**Pacific Gas and  
Electric Company**

PG&E Letter DCL-00-071

License Amendment Request 00-02

Refueling Water Purification System Upgrade and Temporary Reverse Osmosis  
Skid Installation To Support RWST Cleanup During Power Operation

RWP SYSTEM UPGRADE:  
SIMPLIFIED DIAGRAM DEPICTING FLOW  
PATH WITH MAJOR EQUIPMENT SHOWN

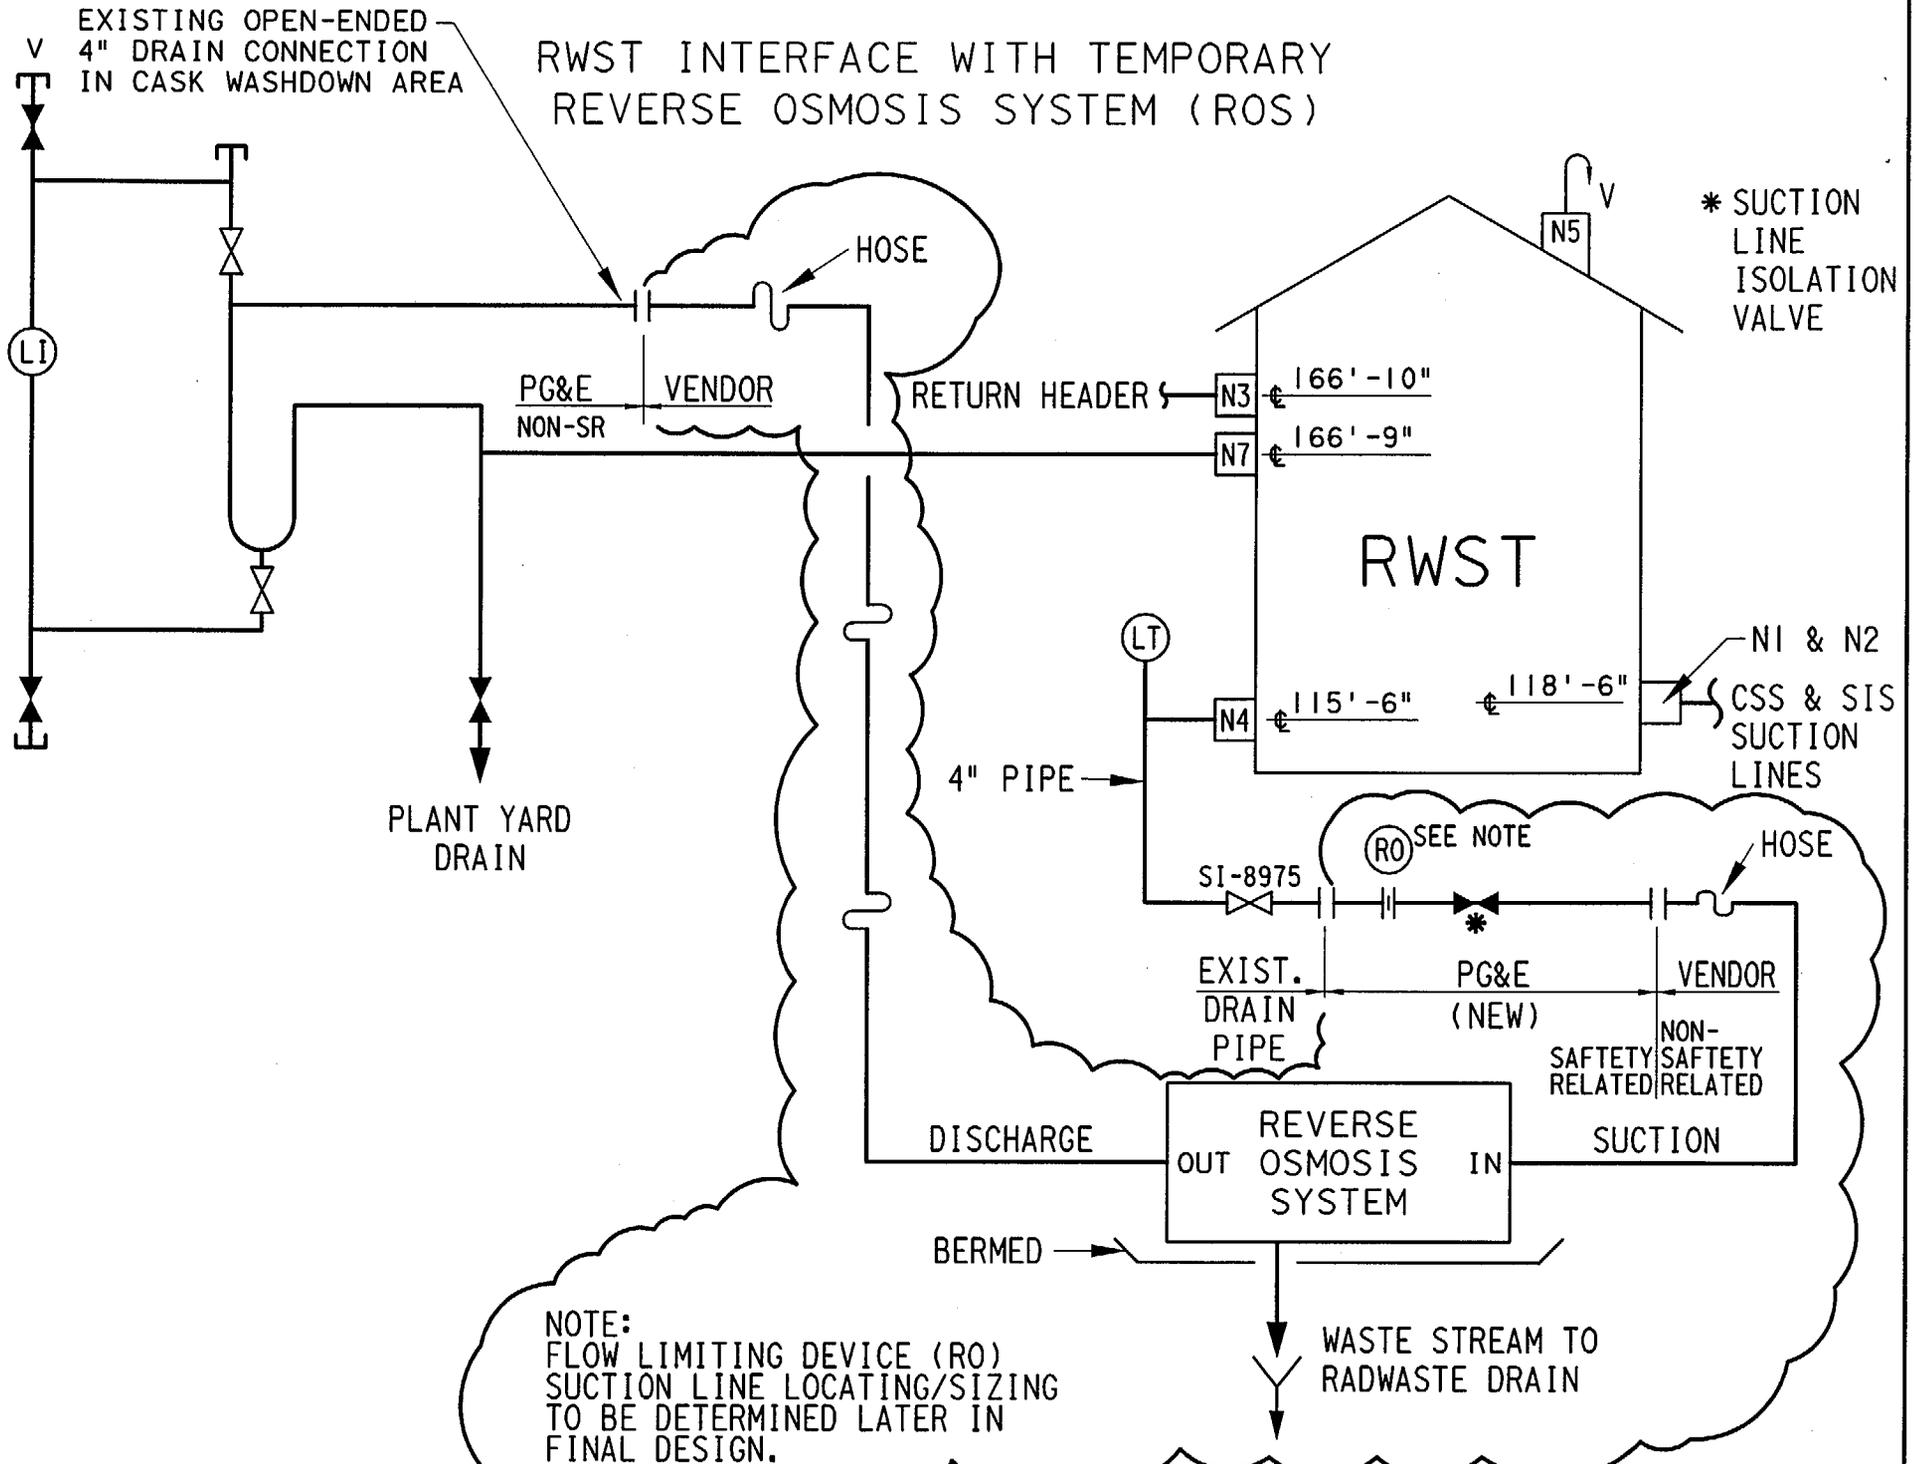
The RWP system is a non-seismic category I, design class II system (PG&E code class "E") which connects to the seismic category I, design class I, quality code class III (PG&E code class "C") RWST piping. Enclosure C contains a drawing of the RWP/RWST interface. The normal suction flowpath is from the main supply header to the ECCS pumps through a manually operated, normally sealed closed code boundary valve (SFS-1-8758, SFS-2-8758). The alternate suction flowpath is through the containment spray pump suction line, through a manually operated normally sealed closed code boundary valve (SFS-1-8788, SFS-2-8788), and a manually operated normally closed valve (SFS-1-72, SFS-2-72) upstream. The alternate suction flowpath will not be included as part of the RWP system upgrade since it is only used during Modes 5 and 6, during which time the boric acid storage system can be credited as the borated water source. The piping in each flowpath is a nominal 4 inch diameter in size. The discharge of the RWP system is through the safety injection pump miniflow recirculation header and through a manually operated normally closed valve (SI-1-8973, SI-2-8973). This return header is connected to the RWST at an elevation above that required to meet the minimum TS tank volume. Although this header is above that required to meet the minimum water volume, it is designed as a design class I/seismic category I line.

To allow processing of the RWST contents through the RWP system while the RWST is required to be operable, portions of the RWP system will be upgraded to meet the intent of a design class I/seismic category I piping system.

To support use of a RO system to reduce silica concentration in the RWST, a design change to the RWST piping will be made. A design class I passive flow limiting device will be added to the RWST drain piping connection. The flow limiting device will be sized to restrict the maximum leakage from the RWST inventory such that the minimum volume required by the RWST TS is maintained under maximum pressure drop conditions during a 1 hour operator action period required to isolate the RO system. The maximum RWST leakage flowrate allowable will be minimized and kept to that required to meet the RO system design capacity (currently a capacity of approximately 50-75 gpm). The RWST drain line which provides suction to the RO system does not provide flow to any safety-related equipment. In addition, a design class I manual isolation valve will be added upstream or downstream of the flow limiting device, such that the capability is available to isolate the design class I RWST piping from the non-design class I RO skid. All piping and valves will be designed or qualified to design class I/seismic category I up to the discharge of the flow limiting device or the isolation valve (if it is provided downstream of the flow limiting device). This will ensure RWST pressure boundary integrity during a seismic event.
